Porirua Proposed District Plan (PDP)

Hearing Stream 3 – Natural Hazards

Response to s42A Officer's Report

Statement of evidence of Rodney David Witte.

Figure 1: Submitter 156 – screenshot from Porirua City Council GIS showing fault line and fault rupture zone in relation to 7 Heriot Drive with the addition of a 20m high hazard band plotted in orange either side of the fault line (refer paras 25 and 27.2 of evidence)

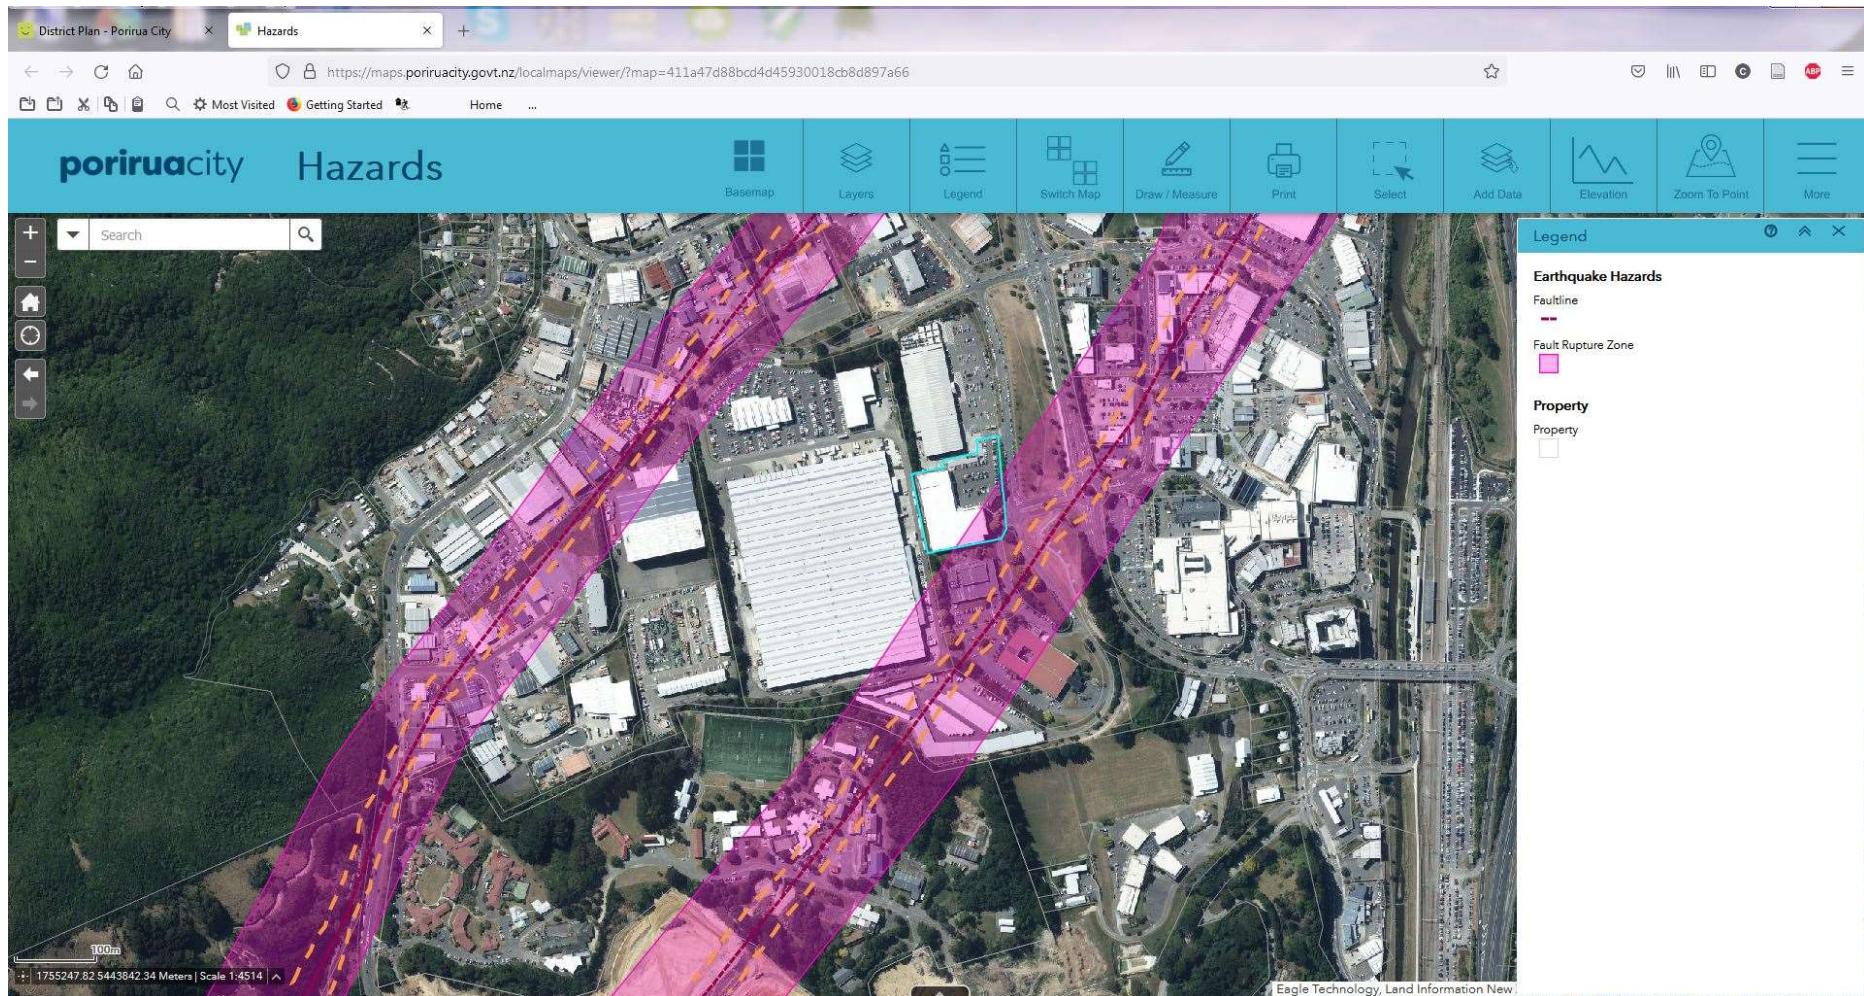
25. Support for the interpretation that there is a single fault line within a fault rupture zone can be found in the publicly accessible Porirua City Council Geographic Information System (GIS) “Earthquake Hazards” pages.

- Attached as an Appendix are figures 1 and 2 which are screenshots from the council GIS showing the Fault line and Fault Rupture Zone as they affect 7 Heriot Drive and 15 Raiha Street.

26. Currently fault lines are not delineated on the PDP planning maps. Without a defined fault line the provisions of Appendix 10 Table 3 and Rule NH-R6 and particularly the word “fault” cannot be reconciled. Such uncertainty creates potential for significant legal challenge in any future resource consent application.

1. A single fault line for at least the Ohariu Fault (and preferably also the Pukerua and Moonshine faults) should be placed on the relevant planning maps. As noted above those fault lines can already be found as a layer on the publicly available Porirua City Council geographic information system (GIS). Consistent with the council GIS I would expect those fault lines to be in the centre of the delineated “Fault Rupture Zone”.

2. Either side of the fault line the planning maps should show a 20m wide band (i.e. 40m total width) and identify this in the plan legend as a “High Hazard Area”. Without access to the council GIS, Mr Garnett has, with limited resources, plotted an approximately 20m band either side of the fault line to represent how it might appear in the planning maps. (Appendix figures 1 and 2). Obviously, it would be more accurately plotted if done on the GIS.

3. The remainder of the “Fault Rupture Zone” (i.e. outside of the 20m wide “High Hazard Area” band either side of the fault line) should be identified in the map legend as “Low Hazard Area”.
